<b>Title of Change:</b>	Update datasheet of DIP-S6 (E4 dimension with tolerance)
<b>Effective date:</b>	29 May 2023
<b>Contact information:</b>	Contact your local onsemi Sales Office or <a href="mailto:Anh.Doan@onsemi.com">Anh.Doan@onsemi.com</a>
<b>Type of notification:</b>	This Product Bulletin is for notification purposes only. onsemi will proceed with implementation of this change upon publication of this Product Bulletin.
<b>Change Category:</b>	Update datasheet of DIP-S6 (E4 dimension with tolerance)
<b>Change Sub-Category(s):</b>	Datasheet/Product Doc change

The purpose of this PB is to inform customers update datasheet of DIP-S6 (E4 dimension with tolerance). E4 dimension with tolerance 125BT, 181AE: 20.6 +- 0.5mm; 125BS: 20.5 +- 0.5mm.

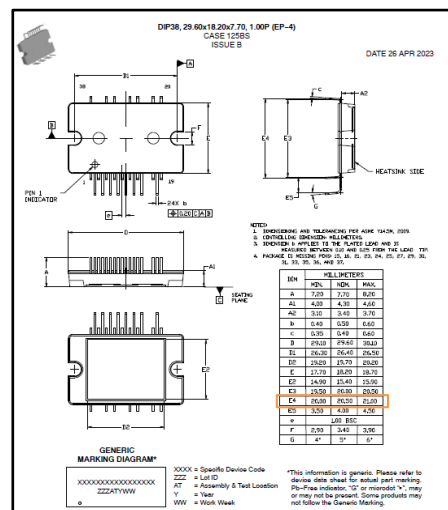
Dimension E4 REF

DIM	MILLIMETERS	
	MIN.	MAX.
E4	20.1mm	21.1mm

DIM	MILLIMETERS	
	MIN.	MAX.
E4	20mm	21mm
